2514 DEXTER AVE NORTH

ADMINISTRATIVE DESIGN REVIEW - RECOMMENDATION PACKET

SDCI Project # 3032686-LU

FRONT AND SIDE FACADES FROM DEXTER AVE N

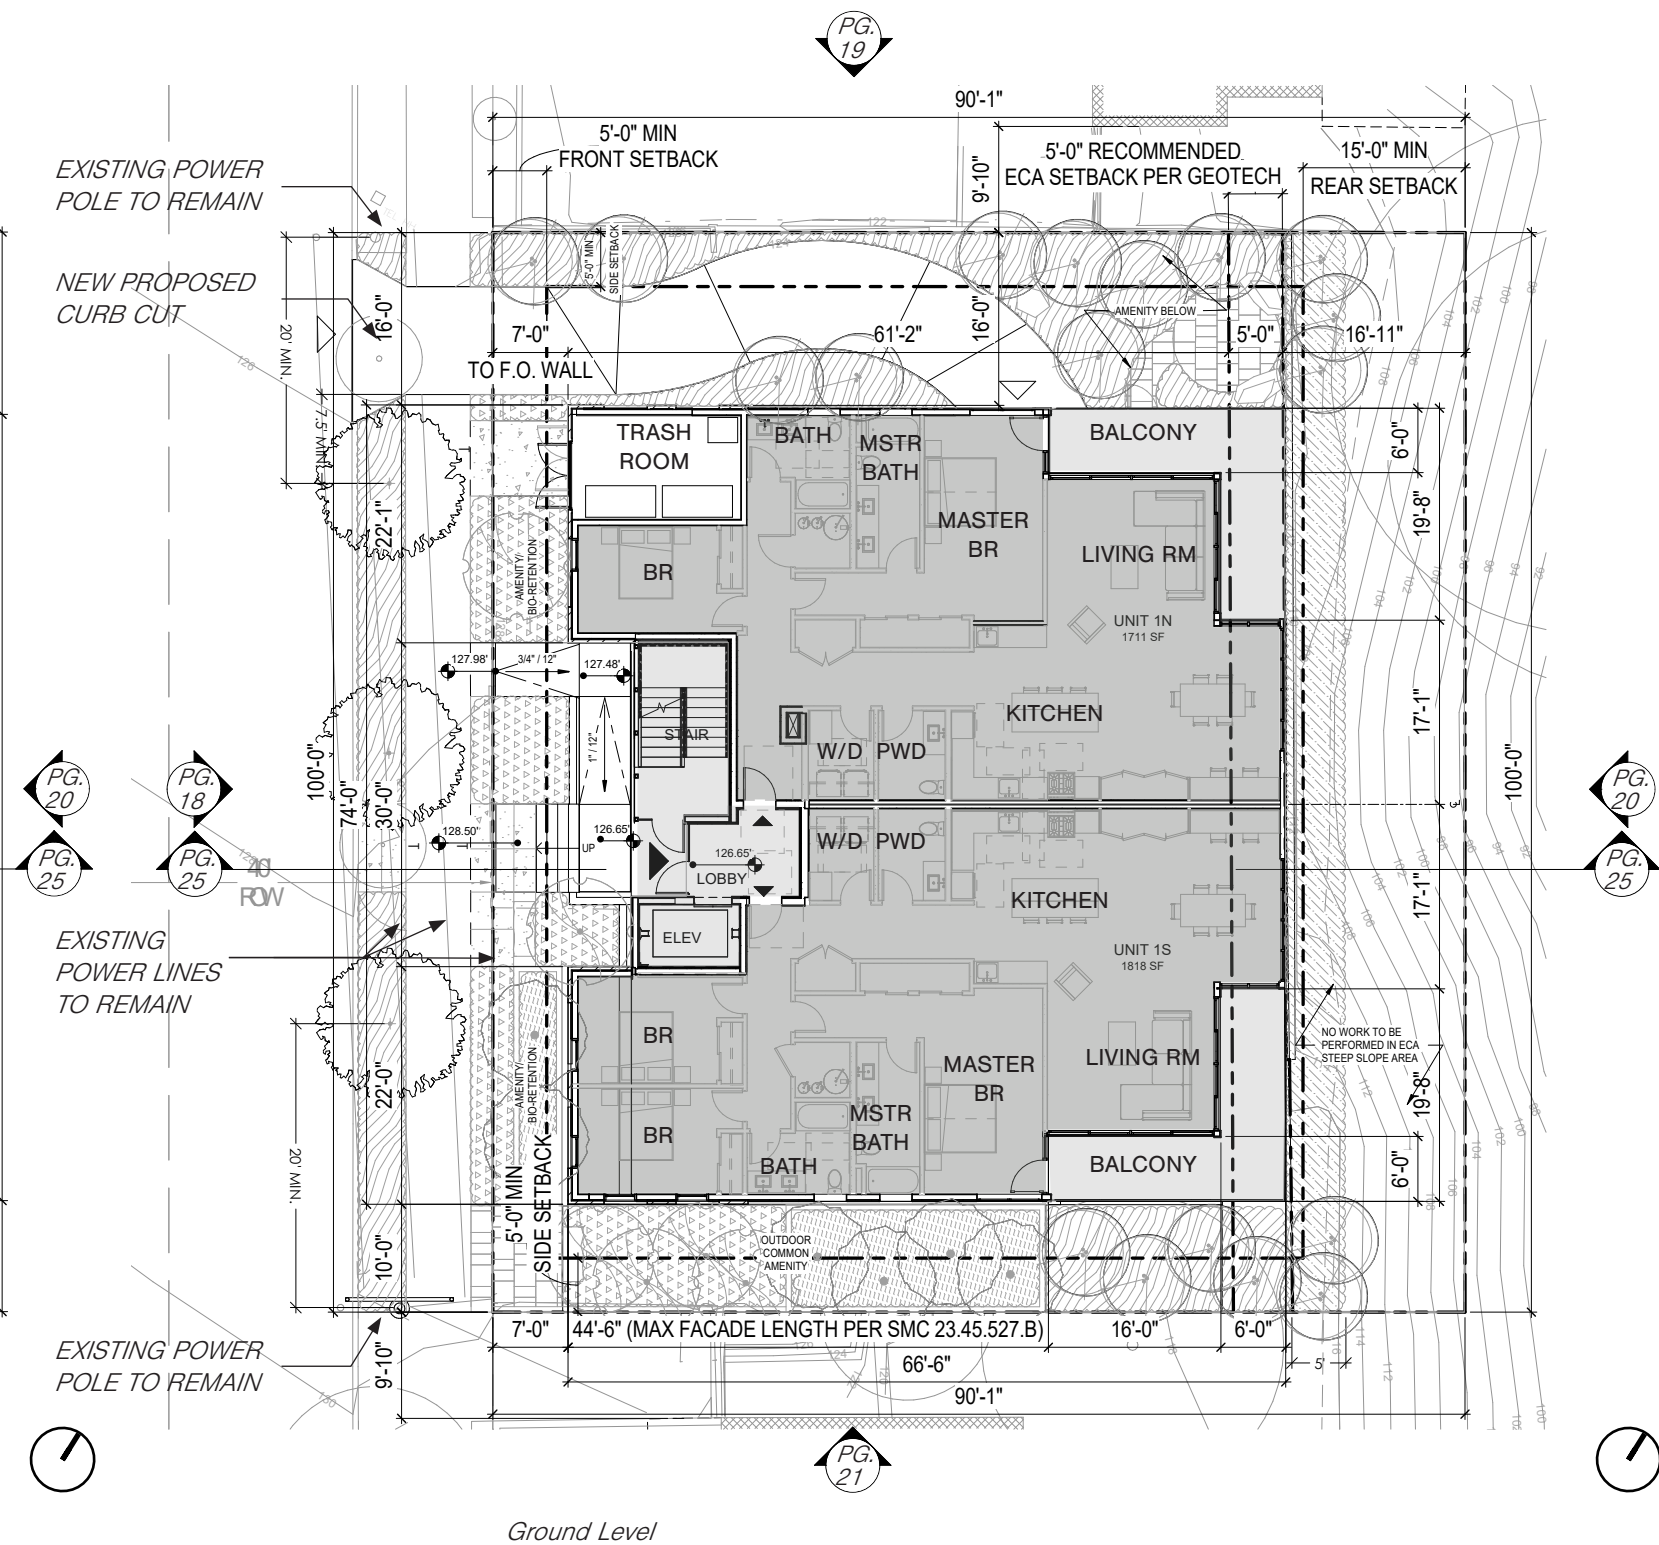
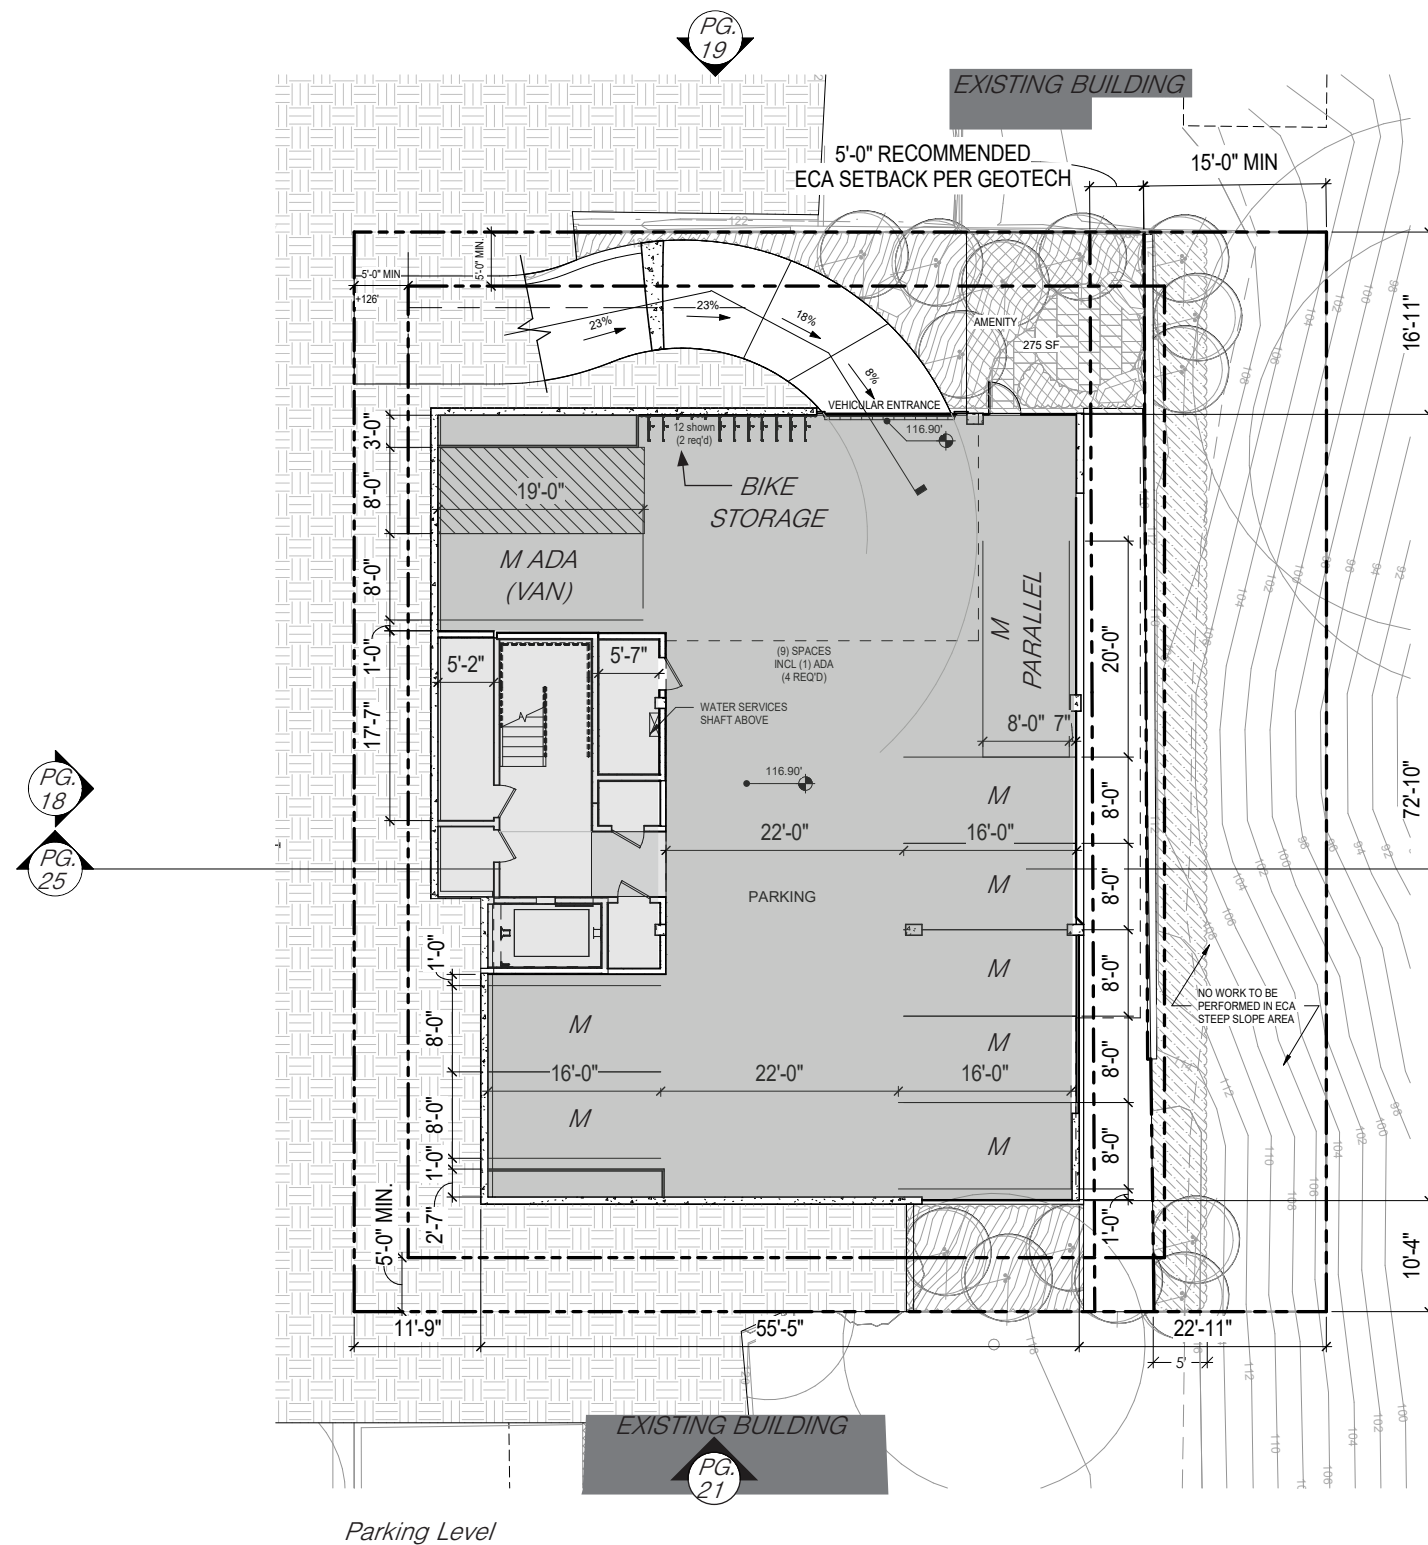
Board Guidance: Staff supports the overall concept of fenestration, exterior circulation and open east facade. Explorations shall be pursued to create cohesion between these elements across the building. Staff recommends the exterior circulation be the focus along the street-facing facade and to use high-quality materials to create an architectural screen system. [Staff strongly supports the use of brick cladding on the street-facing facade and encourages application of the material in a modern way] (see page 12). Careful consideration should be given to how the brick cladding transitions around the building.

Design Response: The primary design elements proposed at EDG have been maintained. The exterior circulation remains the focus of the Dexter facade, providing a “break” from the adjacent brick solids. The traditional brick has been modernized with larger “openings” through the integration of metal siding adjacent to the windows. The two brick masses wrap the building, acting as two solid bookends to the central circulation. Additionally, movable shutters have been added to provide shading and privacy for street-facing bedrooms and to animate the elevation. Wood cladding has been added wherever the solid has been cut away (e.g. the stair on the west, the balconies on the east), as a common expression on all sides of the building.

PROPOSED SCHEME

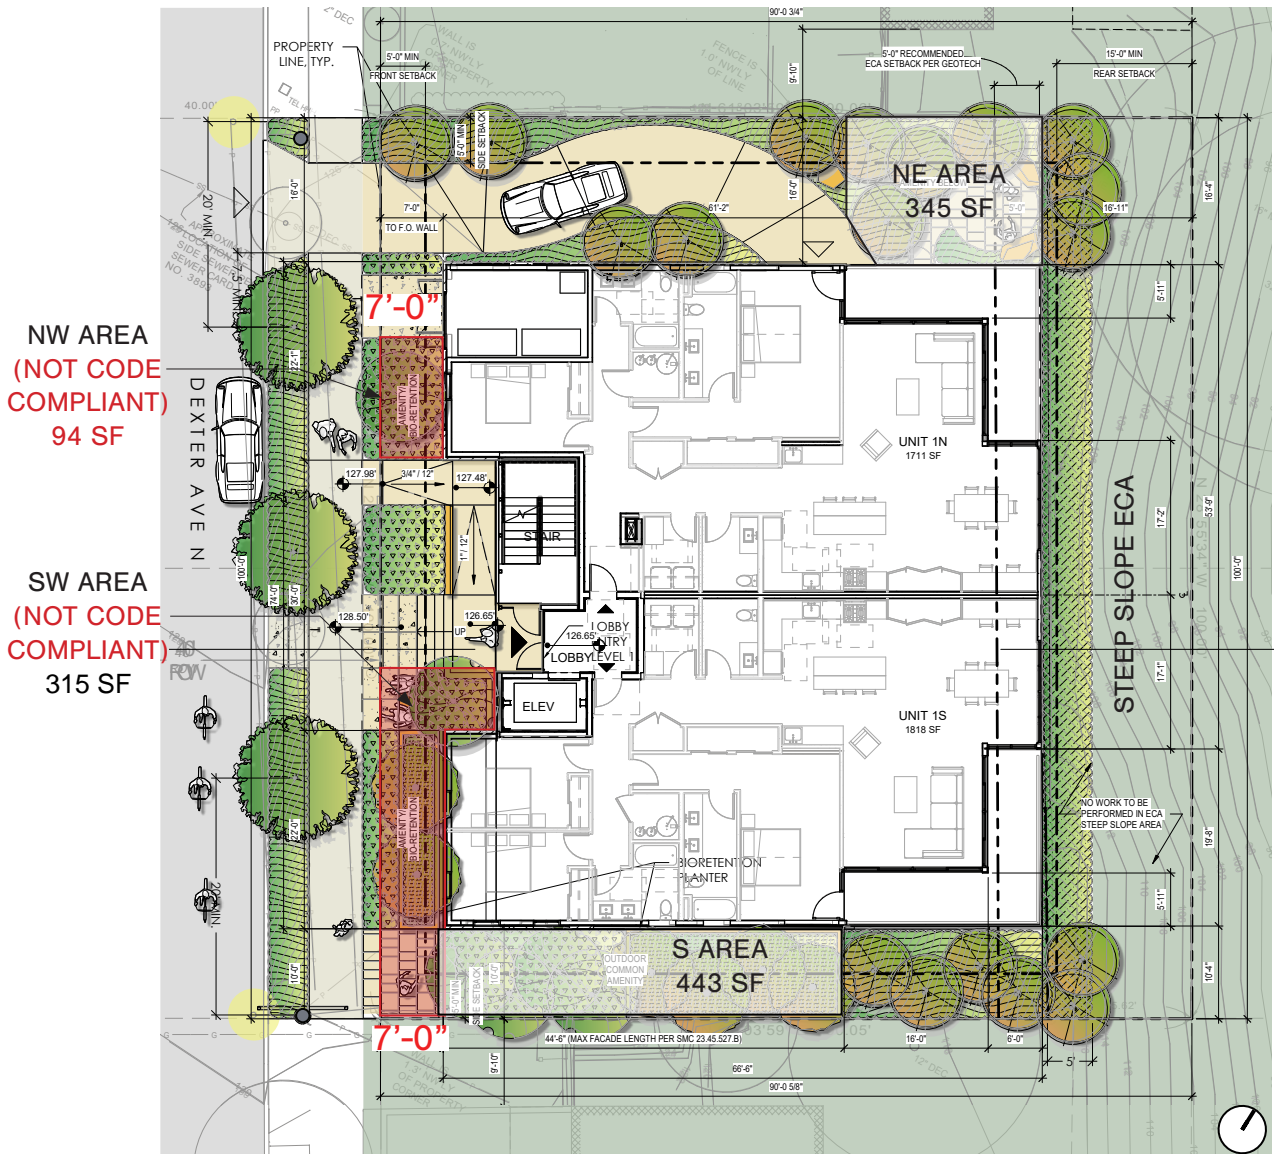
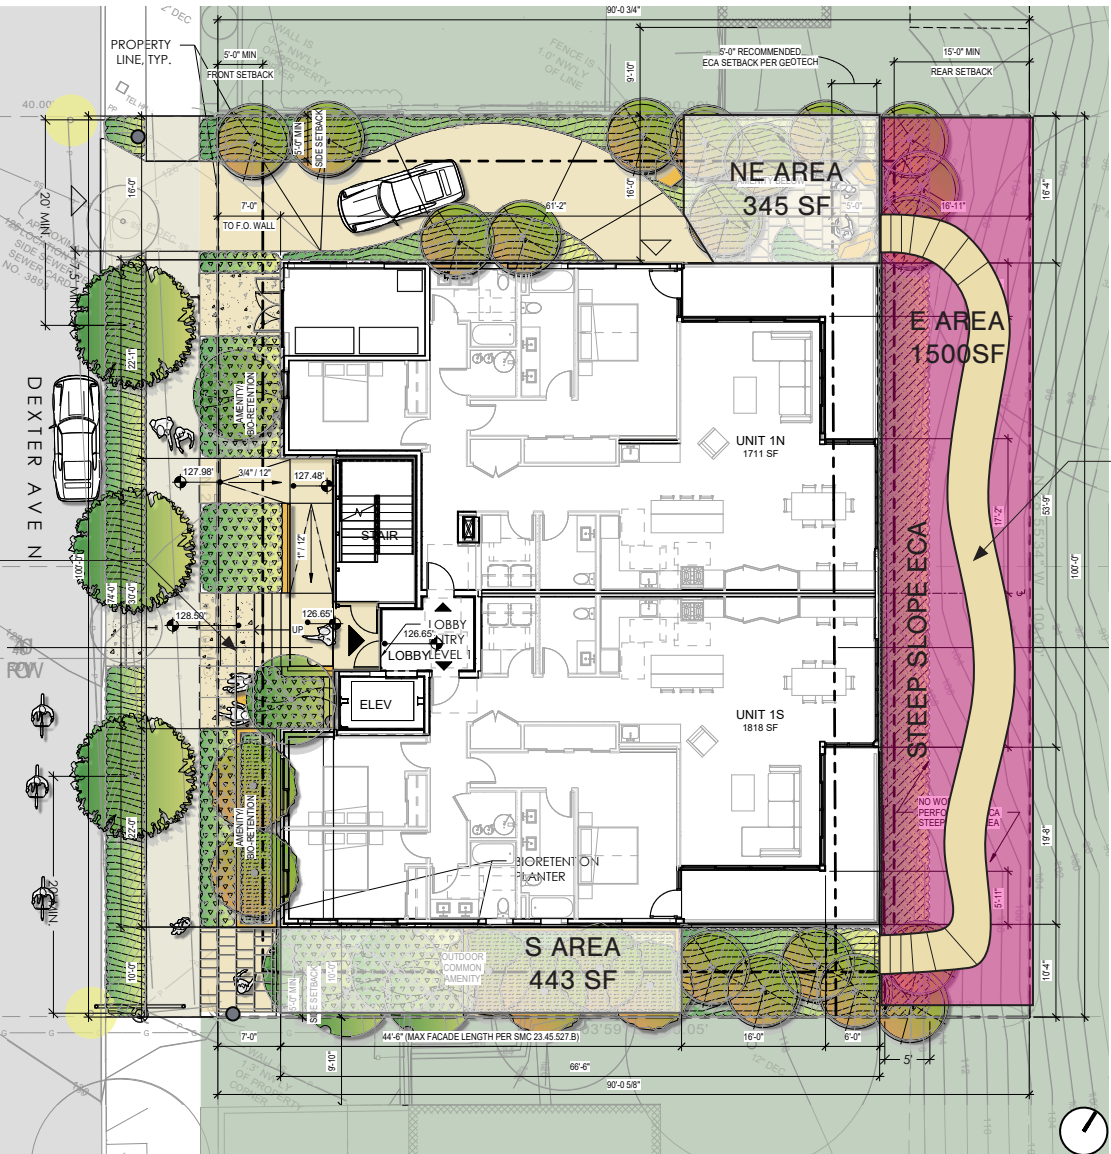
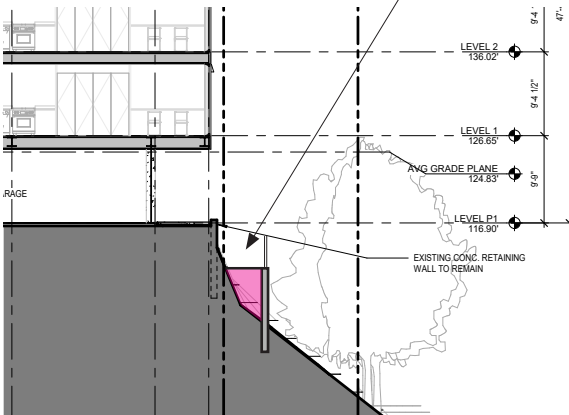
Board Guidance: Staff is concerned with the quality and function of the amenity garden area as proposed adjacent to the driveway. Staff recommends consolidating amenity area and working to create a stronger relationship with interior uses to increase the overall quality and function of exterior amenity area. Study whether other locations on the site may be more successful, such as at the south.

DEPARTURE	CODE REQUIREMENT	PROPOSED DESIGN	JUSTIFICATION
COMMON AMENITY AREA MINIMUM SIZES	<p>23.45.522.D.5.a</p> <p>The code requires common amenity spaces to not be less than 250 sf in area and to have a min horizontal dimension of 10'.</p>	<p>NW Amenity Area is 7' min width and 94sf.</p> <p>SW Amenity Area is 7' min width.</p>	<p>The buildable area of the site is limited due to topography and required setbacks, including the ECA on the eastern portion of the site, the geotechnical engineer's recommended setback from the top of wall, and the power lines to the west. The massing of the building has been determined by these site characteristics and requires common amenities to be smaller and interspersed throughout the site (DC2.A.1:Site Characteristics and Uses).</p> <p>A code-compliant scheme would force us to utilize the Steep Slope ECA at the eastern edge of the site, which would allow for an additional 1500 sf of ground-level amenity space. Although such a "nature trail" in a Greenbelt-type setting would be desirable, it would also require work in an ECA that is generally discouraged by SMC. Furthermore, such a path could dangerous without infrastrural improvements (the slope is 65% per the Geotechnical Report) and would not be ADA compliant, which is undesirable (PL2.A.1: Access for All).</p> <p>Feedback from the community outreach yielded public comment recommending a diversified approach to open space in order to provide the most flexibility for future uses and turnover throughout the life of the project (DC1.A.3:Flexibility). The multiple smaller amenity areas proposed will provide this diversity.</p>
